SADDLE CREEK RANCH PHASE 2 & 3

PRELIMINARY

WATKINS
SADDLE CREEK - PHASE 2 & 3

PLANNING COMMISSION RECOMMENDATION:

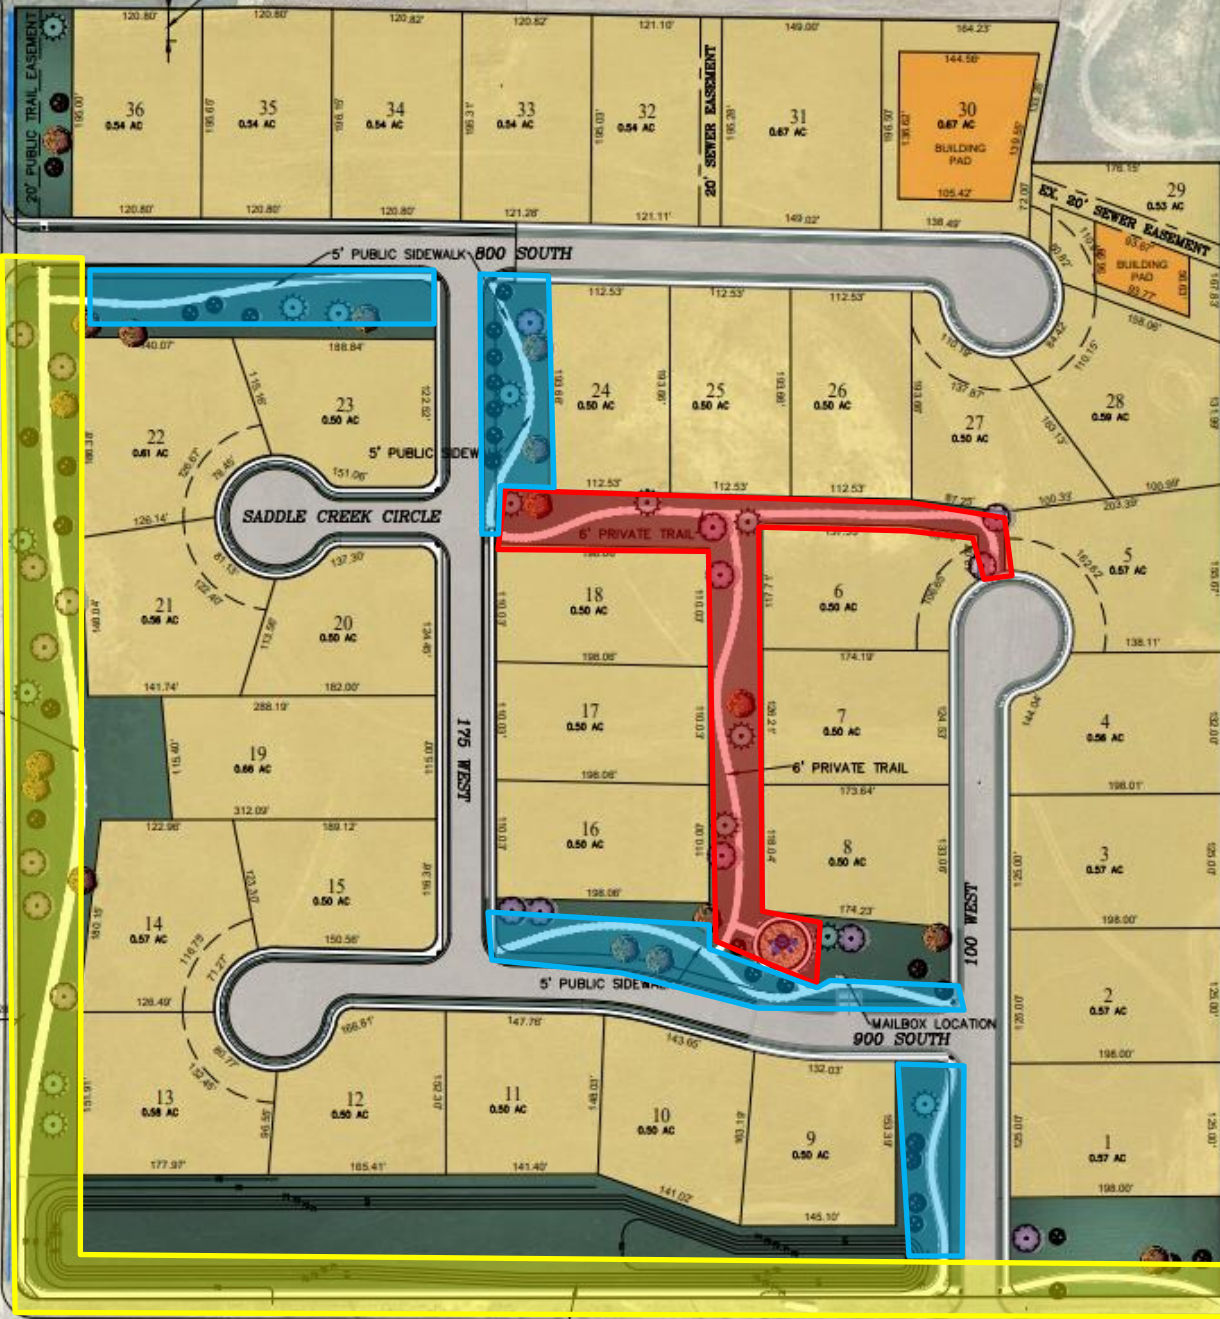
The Planning Commission requested that the Parks, Trails and Tree committee provide a recommendation to the City Council on whether sections of trail within the development, adjacent to roads and within open space, are 5' concrete as recommended by City staff or 8' asphalt as proposed by the applicant. Staff has recommended concrete primarily for maintenance purposes since the city will be maintaining them, the applicant would prefer asphalt because of the aesthetic and user experience.

Motion: Amanda Peterson: I make a motion that we recommend to the City Council that public paths within the development that are adjacent to roads and are within open space, are constructed as 8' asphalt trails. The reasoning is it will be safer, provide increased width and will enhance the continuity of trails within the open spaces.

Nays: Committee Members: Coleman – Agrees with the 8' asphalt trail but would like it to continue along 175 West in front of the proposed lots on east side of the street.

After the motion had passed, Committee Chair Bouwhuis requested that the City Council and developer consider the possibility of making all trails in the development publicly accessible (currently two sections of trail that are not adjacent to roads are anticipated to be private) and that the developer/HOA contribute annually to have the trails included in the City's trail maintenance program.

- 8' Asphalt (Public)
- 5' Concrete or 8' Asphalt (Public)
- 6' Asphalt (Private) – PTT Committee would like the applicant and City Council to consider these being public and HOA paying City to include in trail maintenance program
